**Wanhao D7 Correction on 23th May 2017**  
**D7 V1.4 to be released on 22nd May 2017**

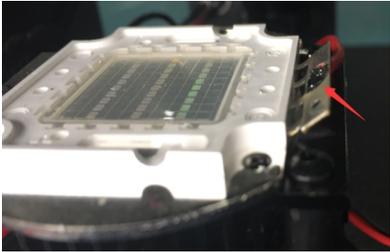
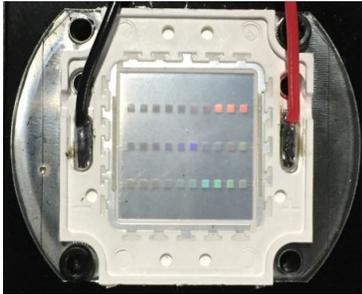
D7 Version 1.3 issue		D7 Version 1.4 improvement	
Pic	issue	Pic	Improvement
	<p style="text-align: center;"><b>1</b></p> <p>We solder the cable on the UV light flange. If worker foget to bend the flange or the customer replace the light may cause short and burn the mother board.</p>		<p style="text-align: center;"><b>1</b></p> <p>We cut the soldering flange and solder the cable onto the UV light directly to avoid short possibility</p>
	<p style="text-align: center;"><b>2</b></p> <p>The power button at front. We have lot issue of LED light.</p>	 	<p style="text-align: center;"><b>2</b></p> <p>All the cable connector , switch are located at same place which at back of printer. Make it very net. There's no button on the front.</p>
	<p style="text-align: center;"><b>3</b></p> <p>We use plastic Anti spacing nut. During shipping some are broken.</p>		<p style="text-align: center;"><b>3</b></p> <p>We change the Z axis plastic Anti space nut to brass one to make Z axis movement more precise.</p>

4

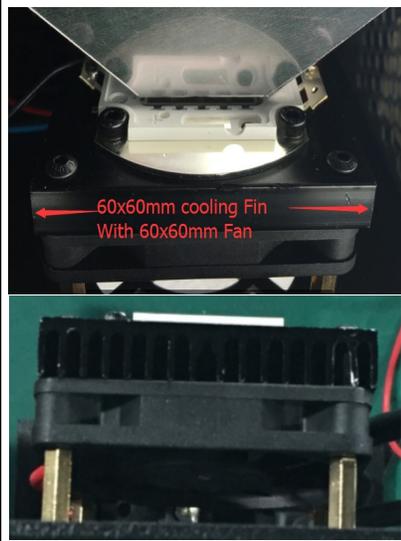
We use 40\*40mm fan and cooling Fin which could cause the printer lack of cooling and too hot to work long time.

We increase the cooling Fin and Fan by 225% to ensure better ventilation. The UV light temperature never get over 40°C.

5

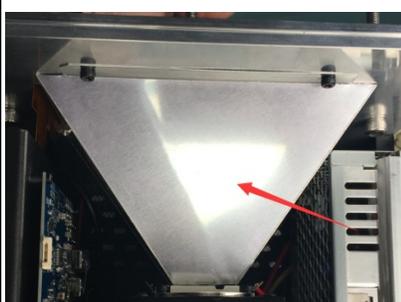
Machining reflector may get scratches during machining.

Molded reflector has less scratches and more reflection.

6

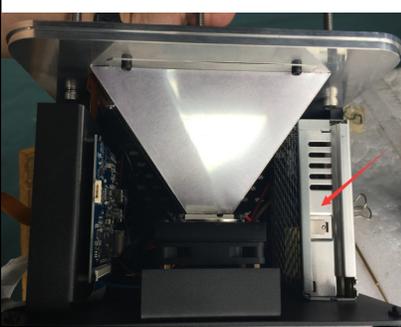
The external 60W PSU is not very much stable. And not neat to pack.

Internal 70W PSU , safer and Net. There's only one power plug for printer.

7

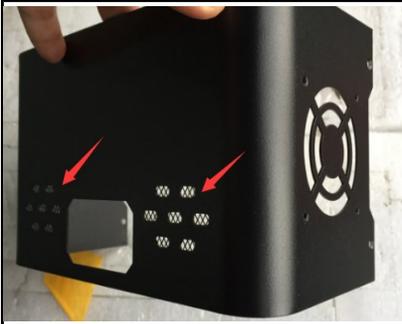
The set screw locking couple has less concentricity.

Embracing couple ensure the better concentricity.

8

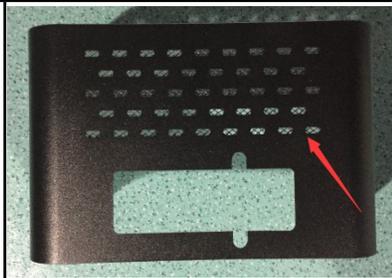
There are 2 series holes at back of printer.

More Vent holes on the back of printer.

9

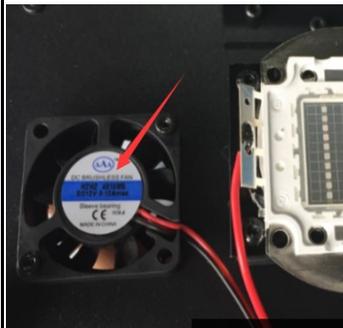
We use punching building plate. The surface flatness is hard to be controlled. Big rejection rate in our production line.

We use the machining building plate with tolerance  $\pm 0.03\text{mm}$  to ensure flatness. And Aluminum plate has good adhesive ability.

10

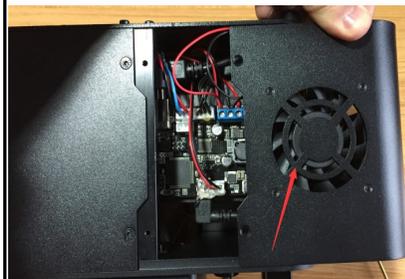
We use 40x40mm intake fan to get air inside.

We use 60x60mm cooling fan above the mother board to ensure the cooling of motherboard and good Ventilation.
